3. HP MEMO - Deering Oaks - Public Infrastructure Alterations

**LEGAL ADVERTISEMENT
HISTORIC PRESERVATION BOARD
CITY OF PORTLAND
Public comments are taken at all meetings.**

On **Wednesday, February 15, 2017** at **5:00** p.m., the Portland Historic Preservation Board will meet in Room 209 of City Hall to review the following items. (Public comments are taken at all meetings):

73 Brackett Street

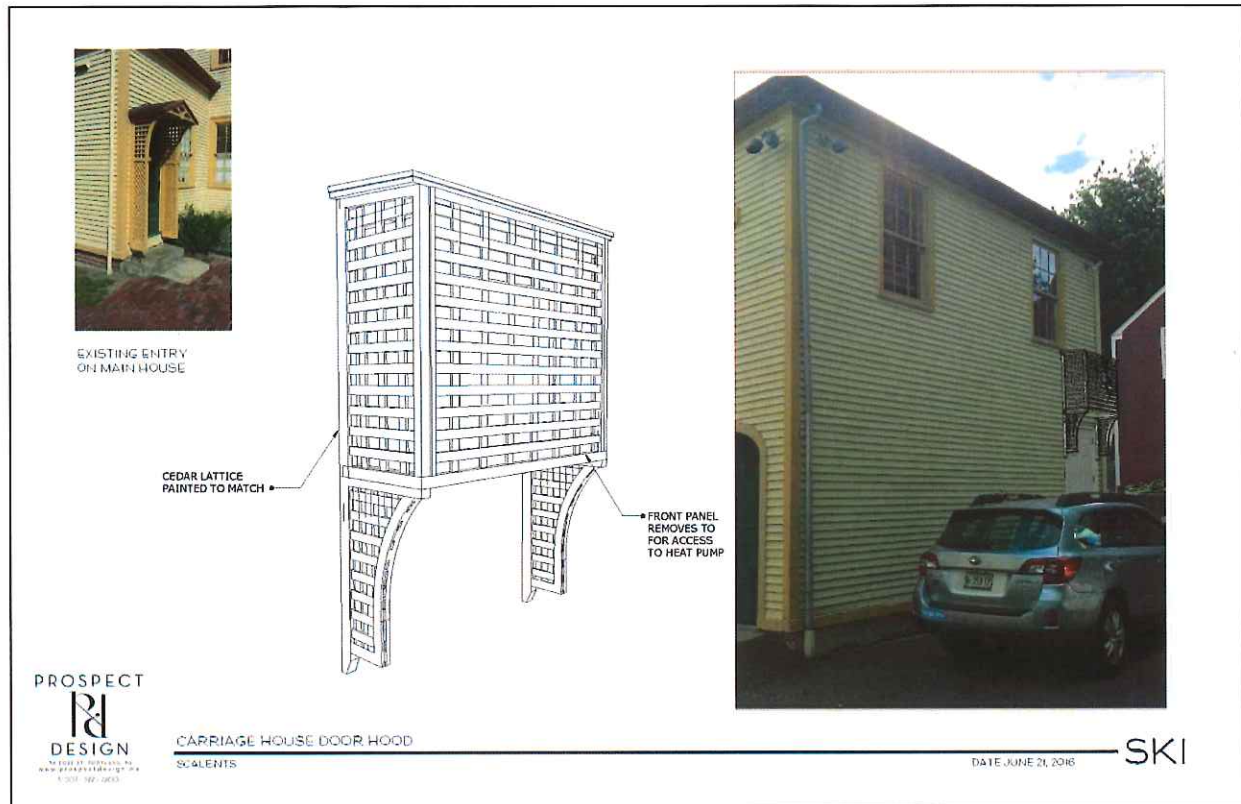
This heat pump was installed before HP staff could review the application. The owners do not own the parking area behind the house, and stated they had no choice but to install the compressor high enough on the wall to avoid interfering with neighbors' vehicles. The owners will be required to paint the compressor and line set covers to match the siding, and staff may seek a latticed enclosure for the compressor.

The installation included a line set cover on the front, facing Brackett Street. HP staff required that it be removed. Tubing now runs inside the house, but a tube for condensate now drains from a spout installed on the wall without review by HP staff.

46 Cushman Street

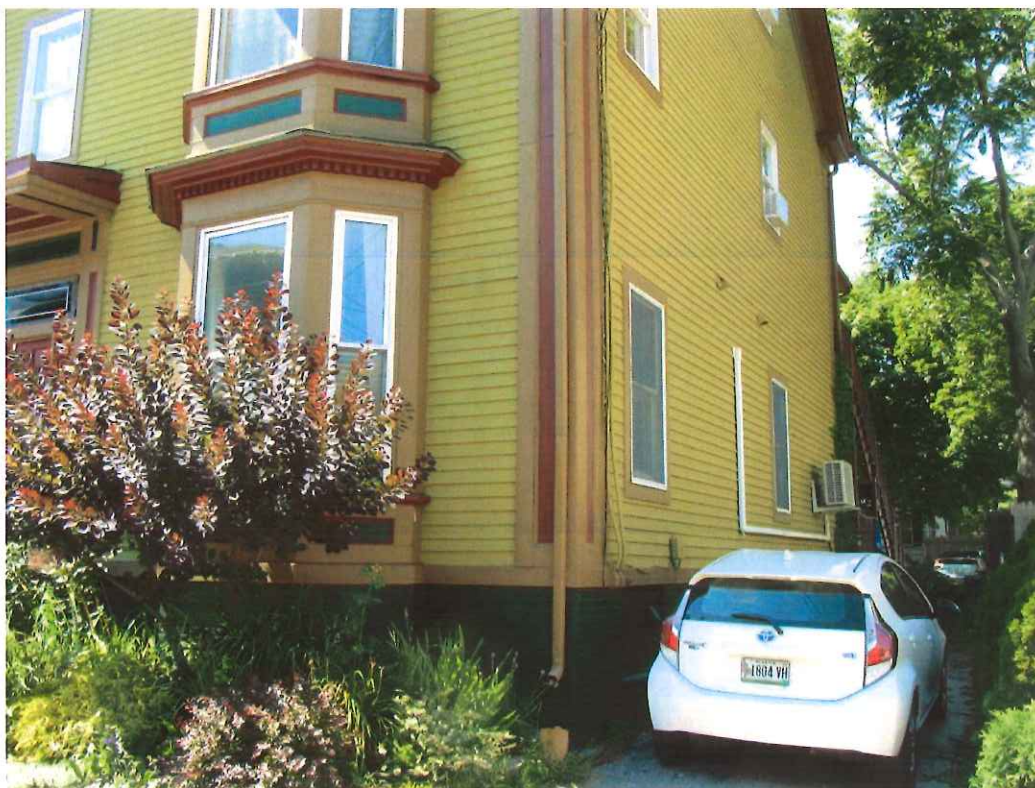
Installed without HP review, this compressor needs to be moved to the rear of the roof, and may require a screen. The line set cover on the mansard needs to be painted black to match the roofing.
